**NRC ADVANCED MANUFACTURING PROGRAM (AMP)
WINNIPEG, MB**

<u>Contents</u>	<u>No. of Pages</u>
Addendum No. 5	89
<u>Attachments:</u>	
Specification Section 03 35 50 Concrete Floor Finishing	3
Specification Section 07 52 00 Modified Bituminous Roofing Membrane R1	7
Specification Section 08 39 53 Blast Resistant Steel Doors and Frames	3
Specification Section 22 15 00.R1 Laboratory Gas Systems	8
23 06 40.13 Silencer Schedule	1
23 06 80.13 Cabinet, Fan Coil, and Unit Heater Schedule	2
DA-099 – PARTIAL A106 – PLAN – LEVEL 1 - WEST	1
DA-100 – 6/A800 – INTERIOR ELEVATIONS	1
DA-101 – PARTIAL A202 - RCP - LEVEL 1 - WEST	1
DA-102 – PARTIAL A203 - RCP - LEVEL 1 - EAST	1
DA-103 – 19/A850 – WASHROOM	1
DA-104 – 25/A850 – WASHROOM	1
DA-105 – Partial A106 – Plan – Level 1 – West	1
DA-106 – 2/A301 – West Elevation	1
DA-107 – 2/A601 – Plan Details – West	1
DA-108 – 3/A601 – Plan Details – West	1
DA-109 – 12/A601 – Plan Detail – West	1
DA-110 – 18/A601 – Plan Details – West	1
DA-111 – A351 – Window Type Schedule	1

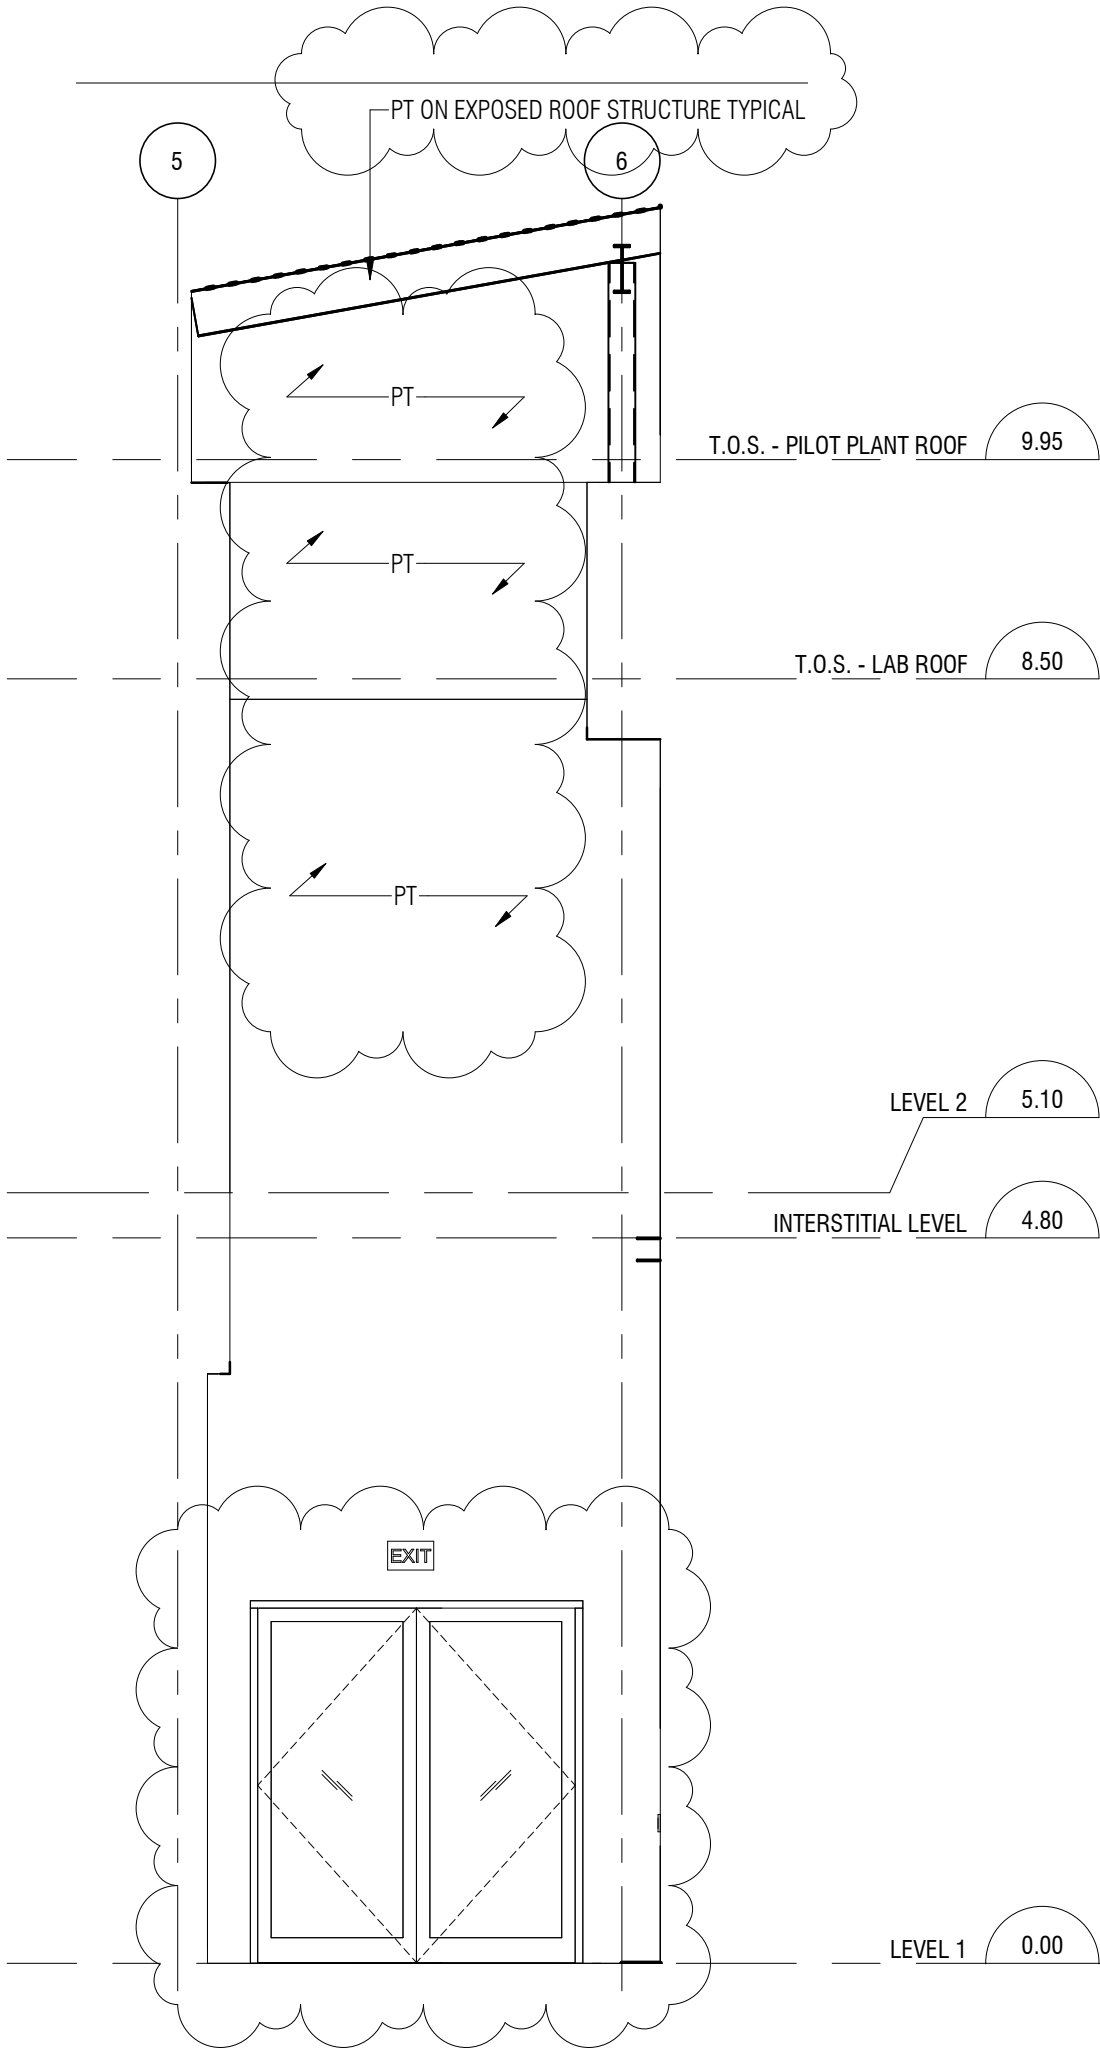
- .1 Drawing A106 is revised to delete door 100B, the associated glazed partition and its associated hardware as well as wall mounted ADO, CR and exit sign.

- .2 Drawing A106 is revised to add new CR to doors 100F, 111 and 113.
 - .3 Drawing A106 is revised to indicate modified layout of the wall mount BP as indicated on sketch.

- .4 Refer to new DA-098 revision sketch attached to this Addendum.
- 4.3 Refer to Drawing A108 – PLAN – LEVEL 2 – WEST:
- .1 Drawing A108 is revised to delete note "PRC4" at columns at grid line E/6 & E/8, and add new note "FRC4" at columns at grid line E/6 & E/8.

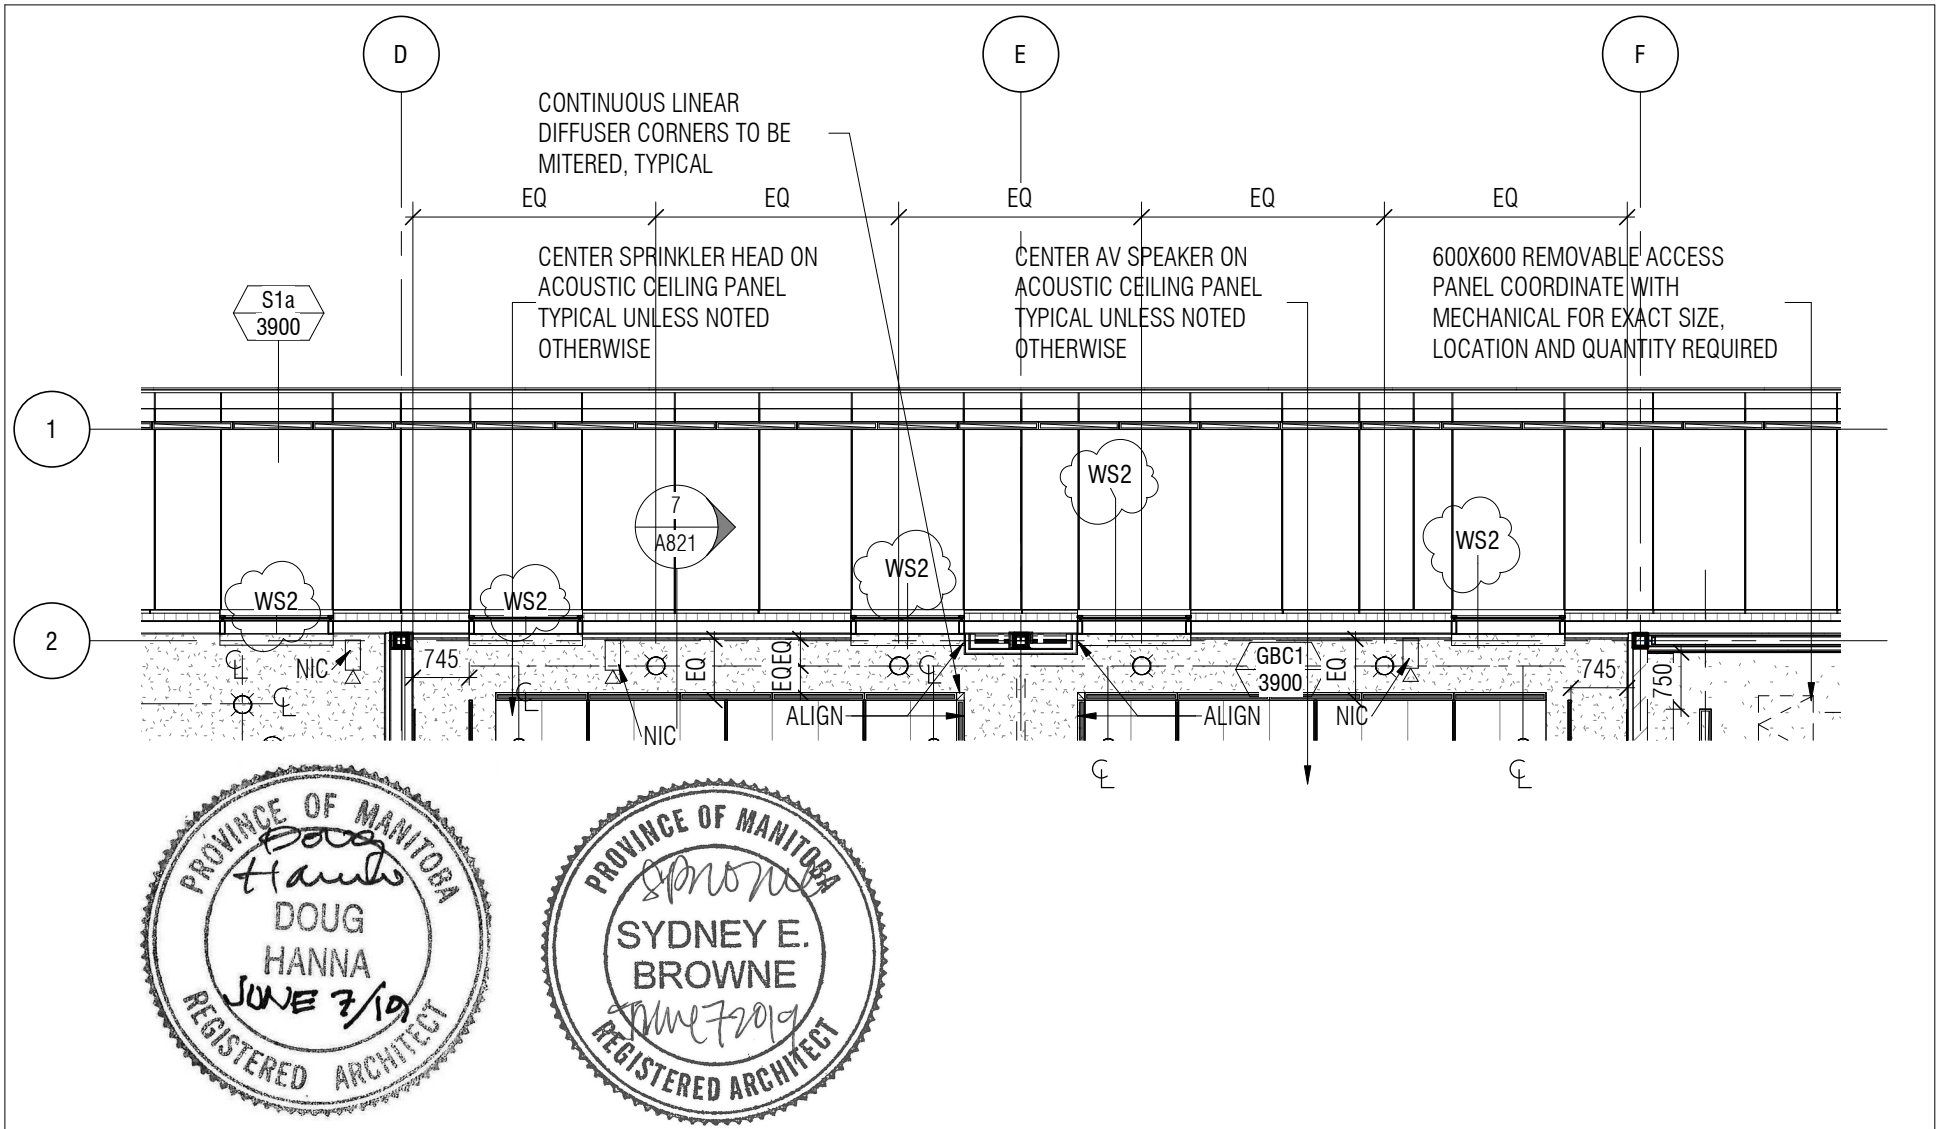
- 4.10 Refer to Drawing A800 – INTERIOR ELEVATIONS:
.1 Detail 6/A800 is revised to indicate new east elevation of PUBLIC CORRIDOR 100B. Refer to new DA-099 revision sketch attached to this Addendum.

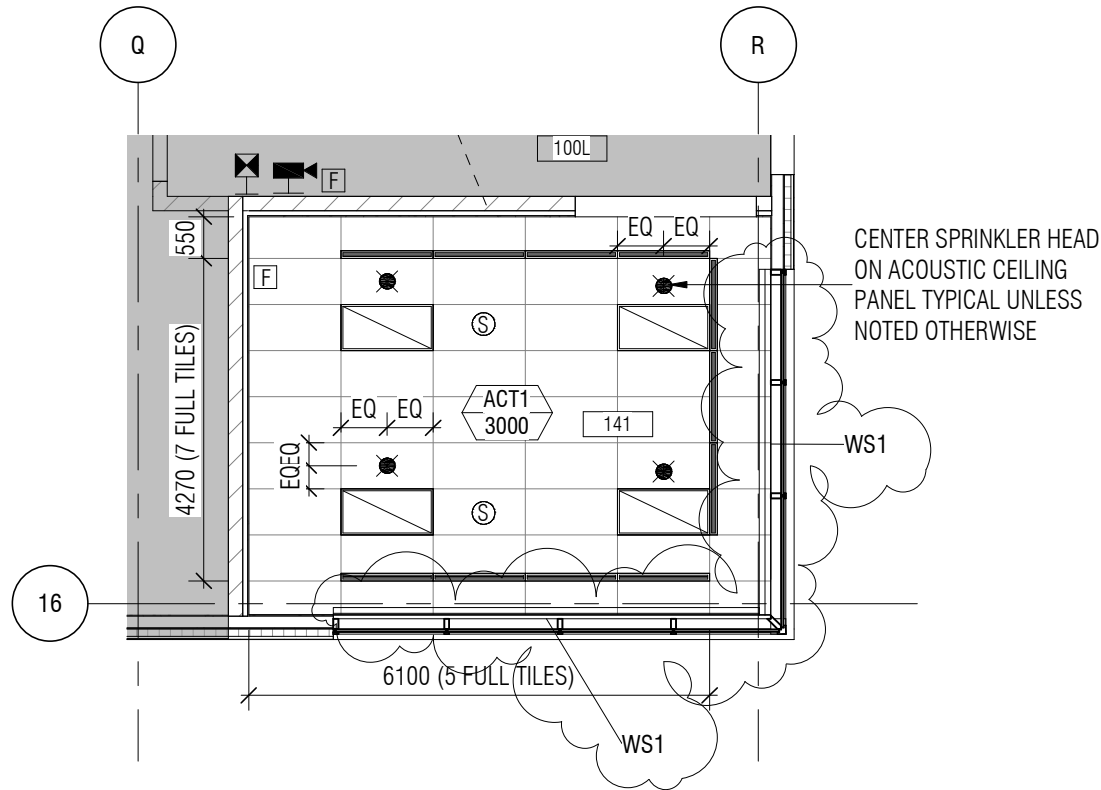
- .4 Drawing A202 is revised to delete all WS4 and add new WS2 in rooms 102, 105A and 105B as indicated on the attached sketch.
 - .5 Refer to new DA-101 revision sketch attached to this Addendum.

DA-102

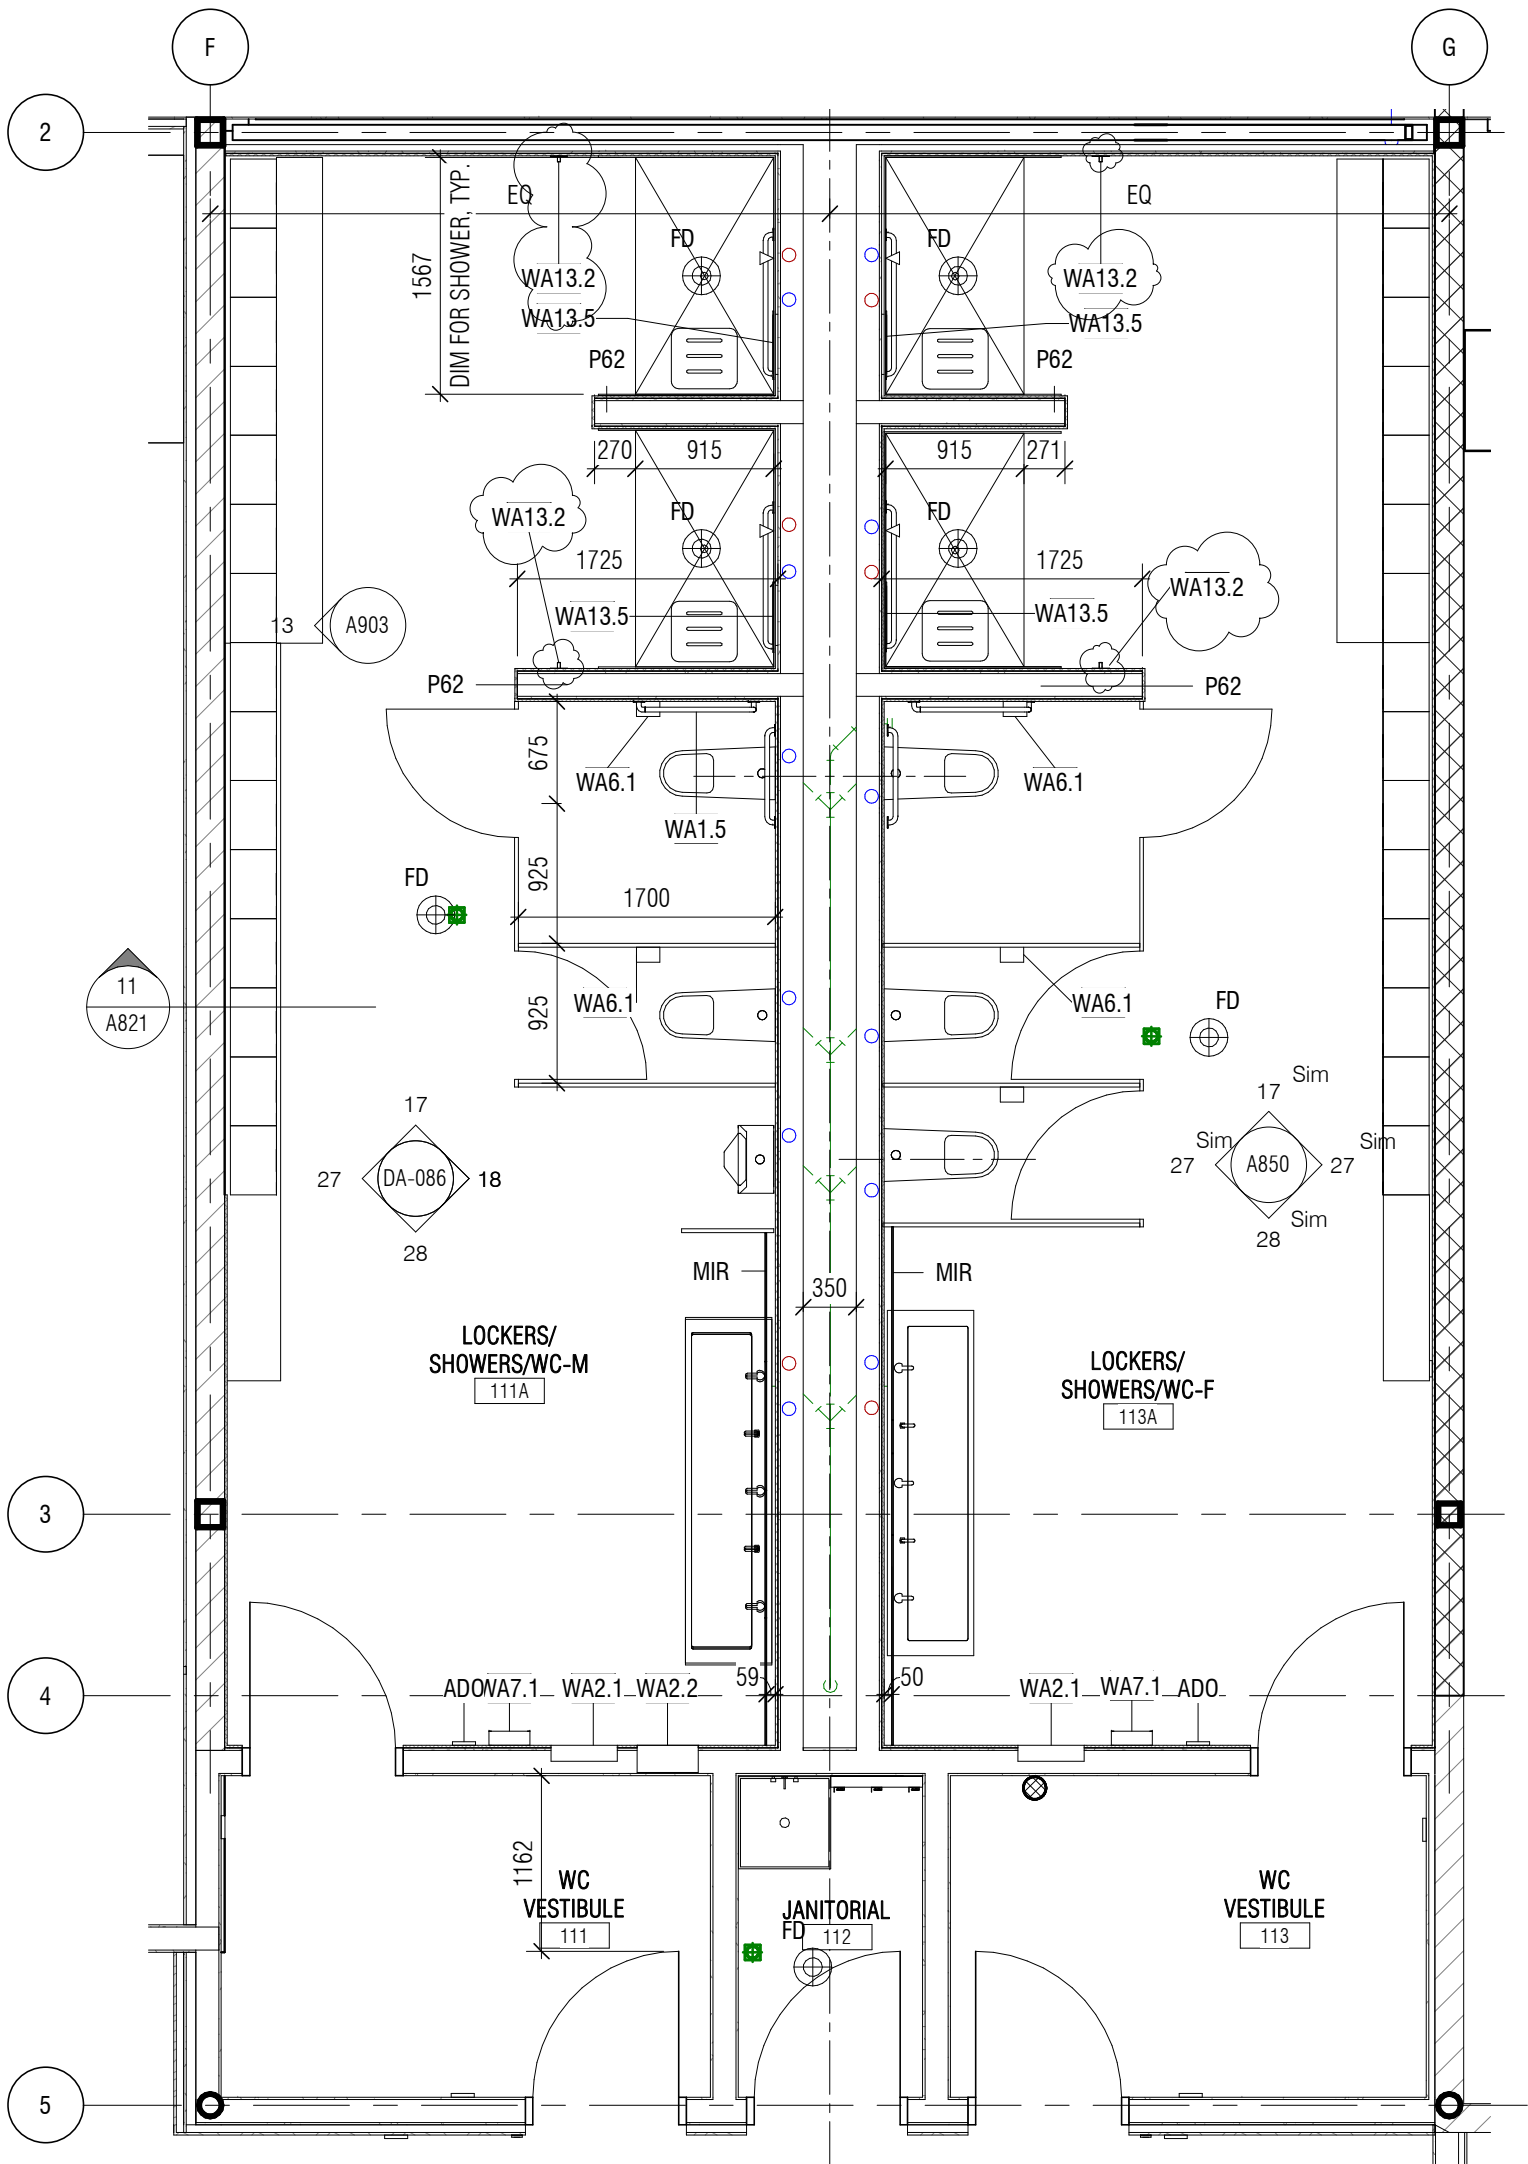
- .4 Drawing A203 is revised to add new WS1 in room 141 as indicated on the attached sketch.
 - .5 Refer to new DA-102 revision sketch attached to this Addendum.
